RE: airport trees

Richland Airport Obstructions Maps

# Richland Airport Runway 27 FAR Part 77 Obstructions

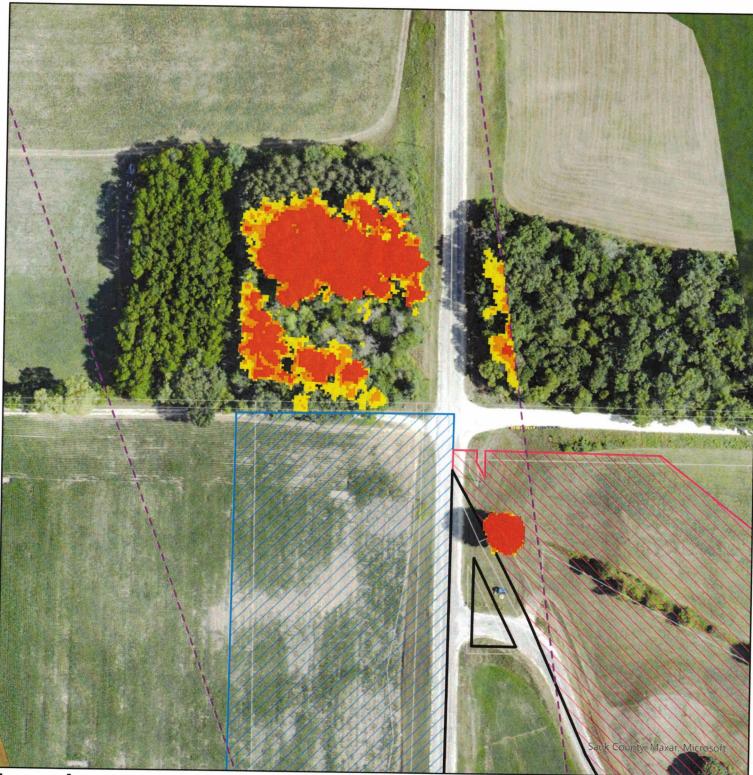
Attached are several maps of the obstructions on runways 17 and 27. The obstructions are shown in red. Trees which are within 5' or 10' of the surface were also highlighted in orange and yellow respectively. Typically, when conducting approach clearing, we also recommend addressing these areas to avoid the need to conduct additional clearing in the near future.

On runway 27, both the Trans 57 and FAR Part 77 surfaces are identical. On runway 17, both surfaces have a 20:1 slope, but the because the FAR Part 77 surface starts 200' beyond the runway end, it is 10' more restrictive than the Trans 57 surface.

The final and least desirable alternative would be to displace the thresholds. The published runway length would remain the same, but the length available for landing on runway 17 and runway 27 would be shortened. By my calculations runway 17 would need to be displaced about 450' and runway 27 would need to be displaced 470'.
